RE: Valero Refining Company – Benicia, California
Planning Commission Use Permit Application No. 07PLN-00032
Revised Environmental Analysis for the Valero Improvement Project Amendments

Attachment I
Response to May 23, 2007 Completeness Review

Response to May 23, 2007 Completeness Review By City of Benicia

Figure 3.1.1-11 Simulation view from Addison Court looking southeast

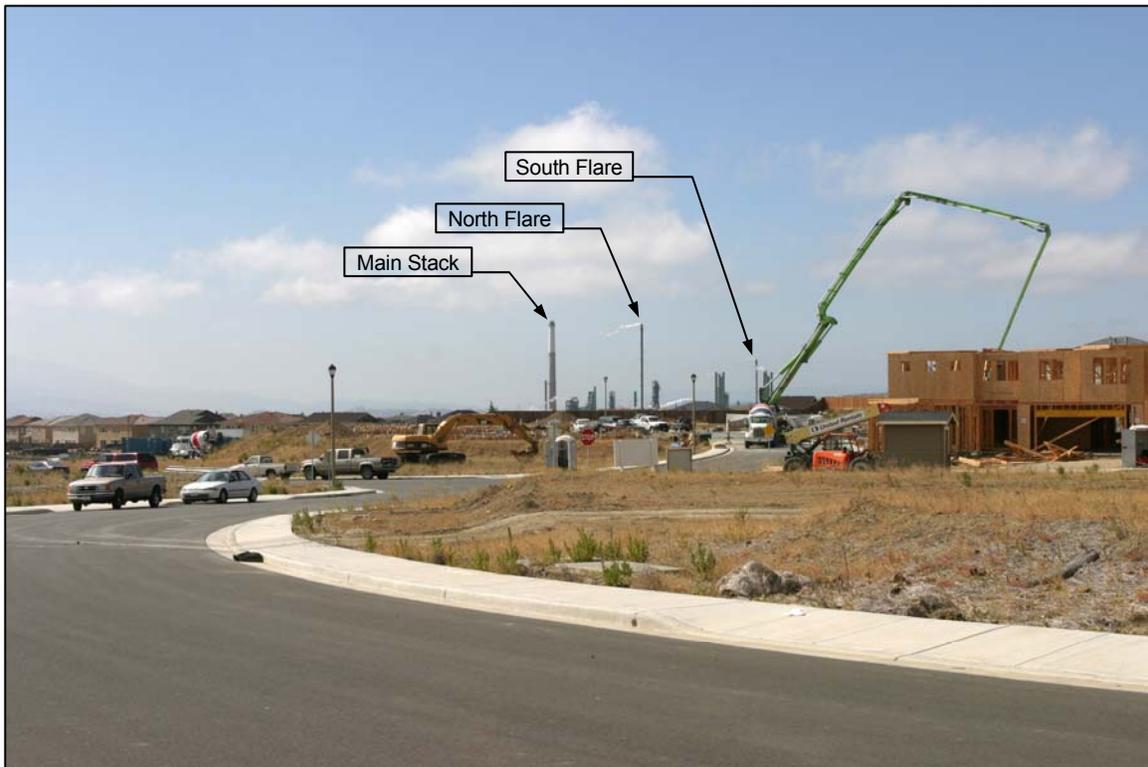
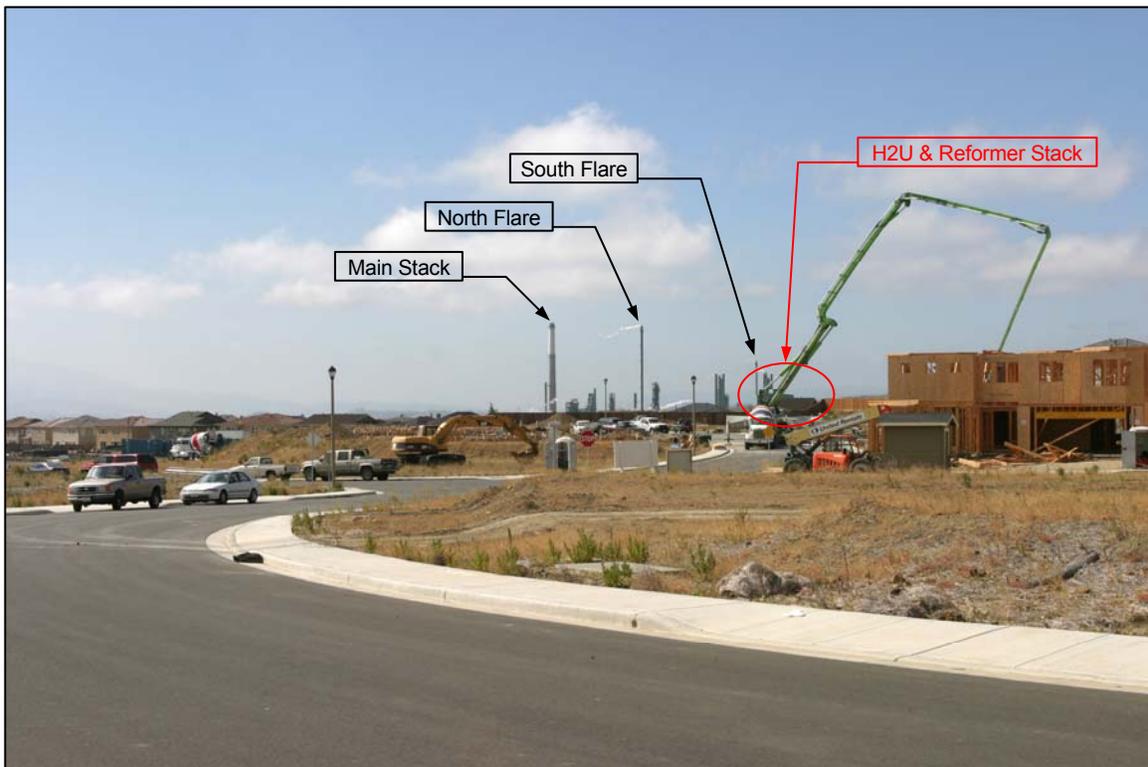
6. ***Additional photo simulations of the proposed construction. New areas of the Southhampton housing development have been constructed since the VIP was approved. (A) If the new hydrogen plant will be visible from those areas, one or more additional photo simulations should be provided. (B) In addition, it would be helpful to clearly indicate the equipment to be added by the VIP amendments on all photo simulations.***

Response: (A) The new areas of the Southhampton housing development were field-surveyed to determine if the hydrogen plant would be visible. A new Key Observation Point photo and project simulation were added for a view from Addison Court looking southeast. The simulation and discussion is provided in Section 3.1.1 of the revised EA.

(B) The photo simulations in the revised EA have been labeled to clearly indicate the equipment to be added by the VIP Amendments on each.
